7 July, 1992

Date: 3 July, 1992

PROFILE OF SEWAGE DISPOSAL SYSTEM	
REPAIR AT 34 ELF HILL RD., AMHERST, MA	
BY: FILIOS ENTERPRISES, INC. 69 PELHAM RD. AMHERST MA 01002 (413)256-8008	FOR: FRANK R. SANING 34 ELF HILL RD. AMHERST, MA 01002
DRAWN BY R. STOVER 21 AUGUST 1991	SCALE: 1" = 10' HOR. 3" VER. PAGE TWO OF THREE

PLAN OF SEWAGE DISPOSAL SYSTEM	
REPAIR AT 34 ELF HILL RD., AMHERST, MA	
BY: FILIOS ENTERPRISES, INC. 69 PELHAM RD. AMHERST MA 01002 (413)256-8008	FOR: FRANK R. SANNING 34 ELF HILL RD. AMHERST, MA 01002
DRAWN BY R. STOVER	SCALE: 1" = 30'00"
21 AUGUST 1991	PAGE ONE OF THREE

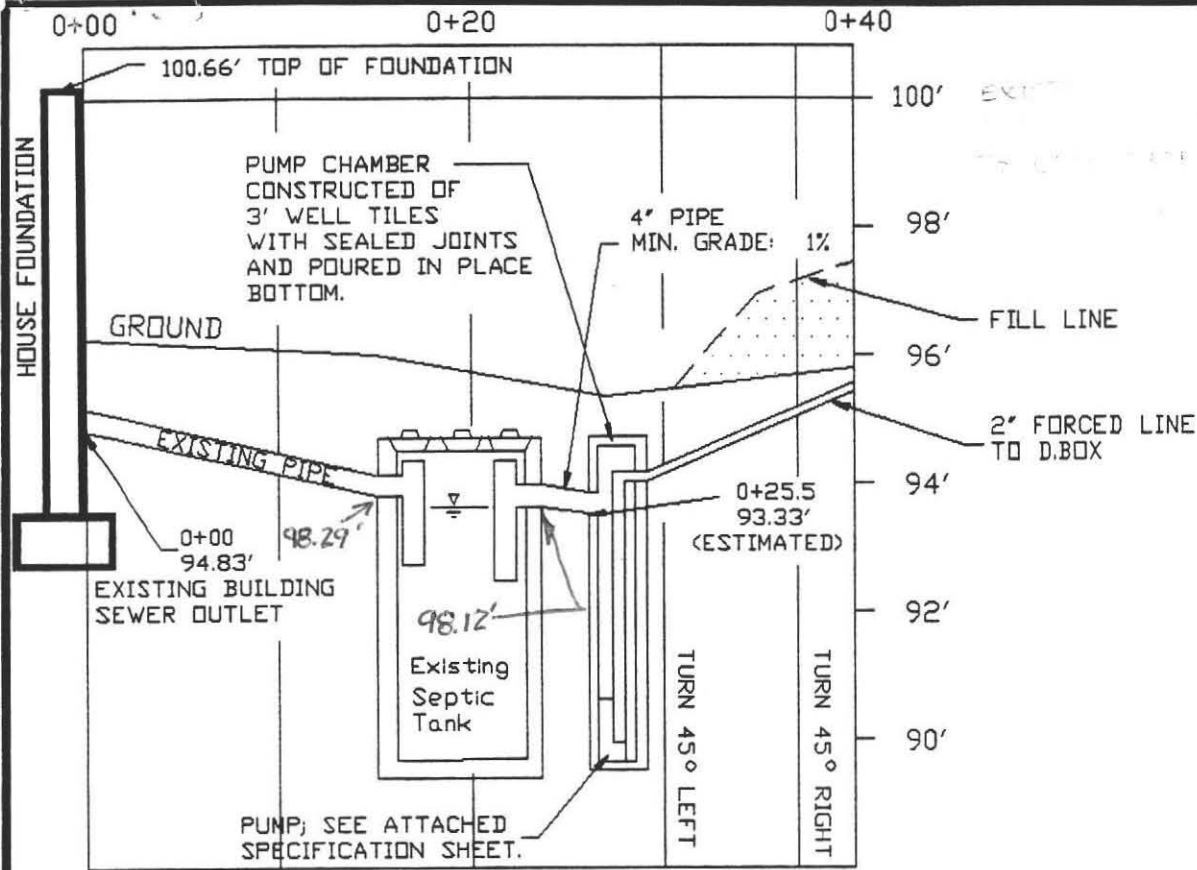
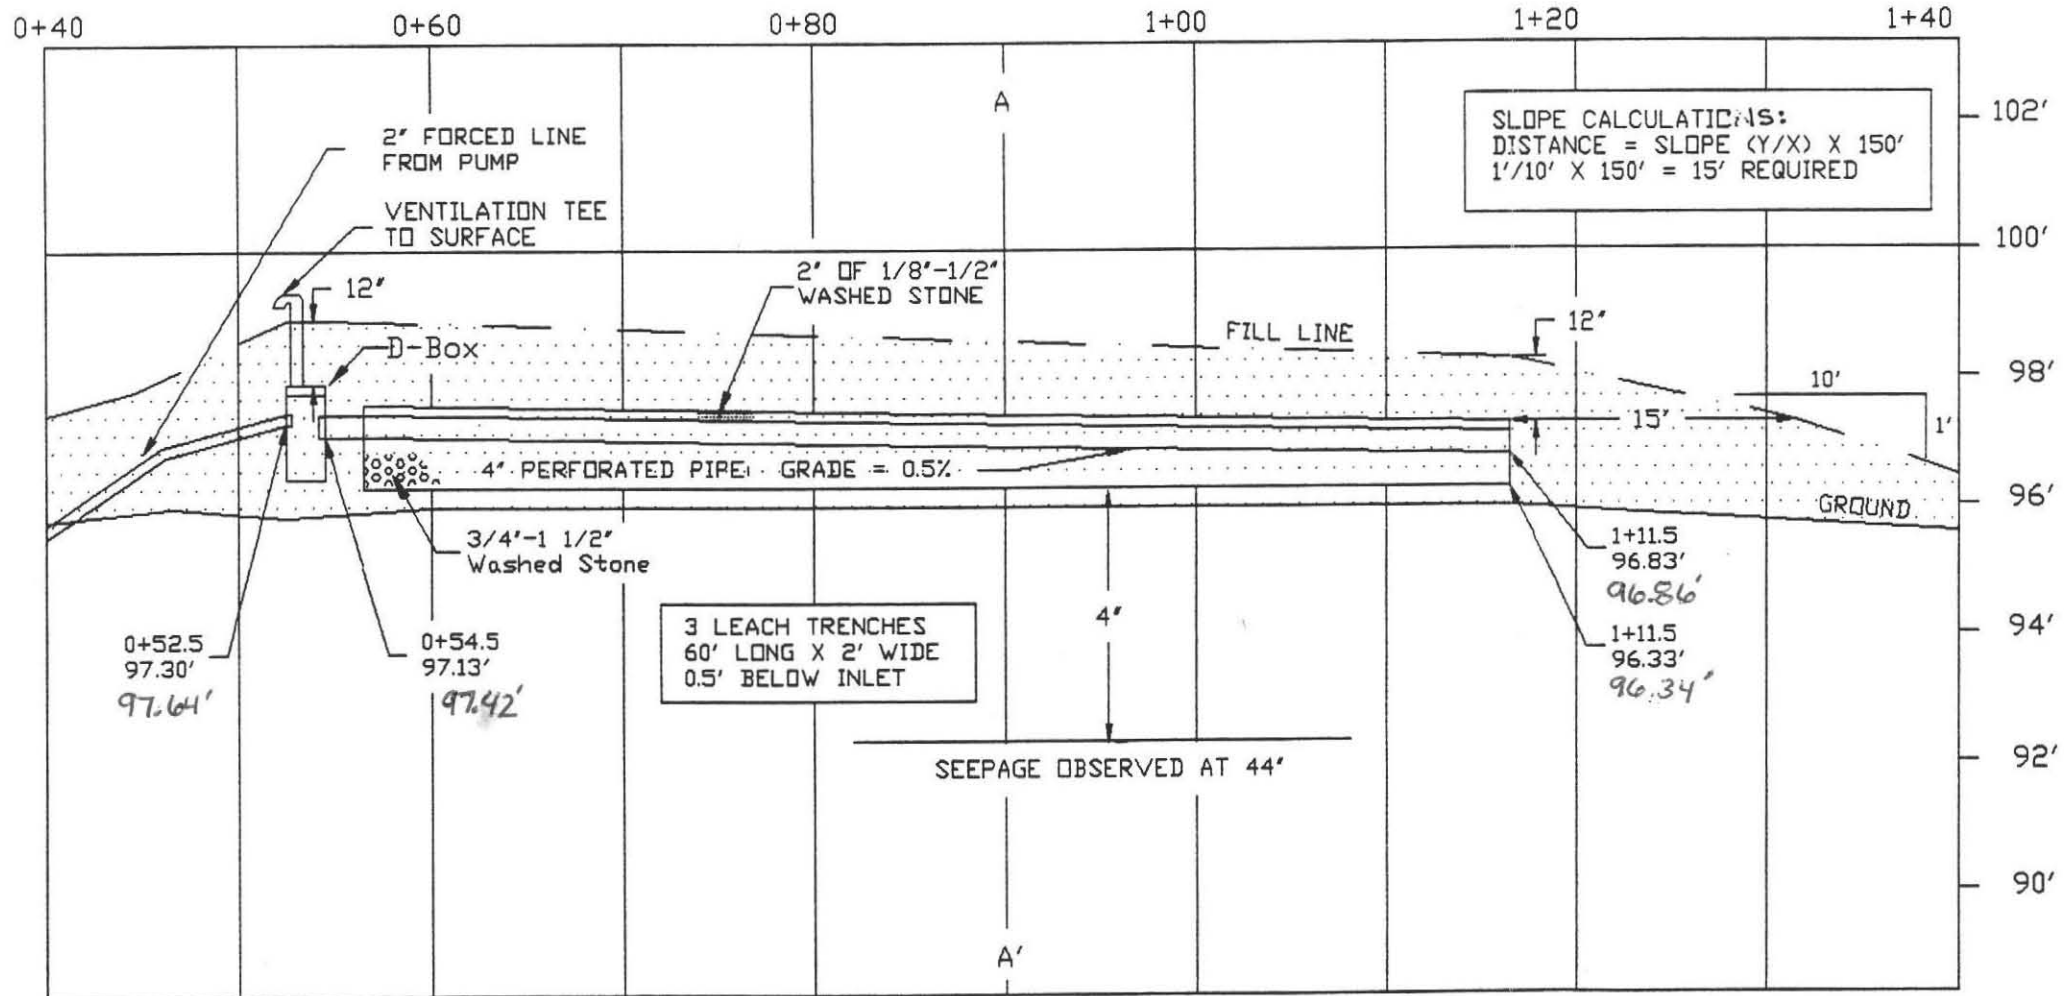
The inspection revealed that the elevations and layout of the as-built system varied from the approved plan to the extent shown in red on the copy of the plan profile and planview enclosed.

- 1.) Building sewer outlet and existing tank raised to eliminate need for pump.
- 2.) Elevations of the as-built system vary from those of the design to the extent shown in red on the copy of the profile enclosed.
- 3.) The layout of the as-built system varies from that of the design to the extent shown in red on the copy of the planview enclosed.
